Technical Service Bulletin

37 Transmission malfunction, DTC P17F600, U008000, and/or U010100 stored in the TCM or ECM

37 19 89 2053878/5 October 22, 2019. Supersedes Technical Service Bulletin Group 37 number 19-88 dated August 14, 2019 for reasons listed below.

Model(s)	Year	VIN Range	Vehicle-Specific Equipment
A6, A7	2019	000001 - 121296	3.0TFSI

Figure 7. New routing and wrapping of the aft part of the transmission harness.

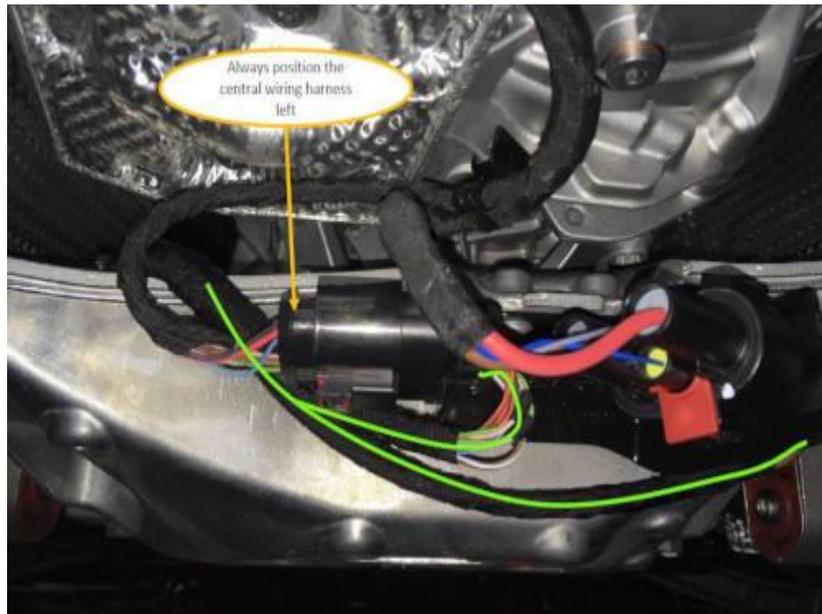
3. Replace the original transmission harness with a new part and reroute the transmission harness. The transmission harness should not be repaired.
 - Remove the original transmission harness in the vehicle.
 - Wrap the exposed wires on the new transmission harness as shown in Figure 7.
 - Mount and route the new transmission harness as shown in Figure 8.
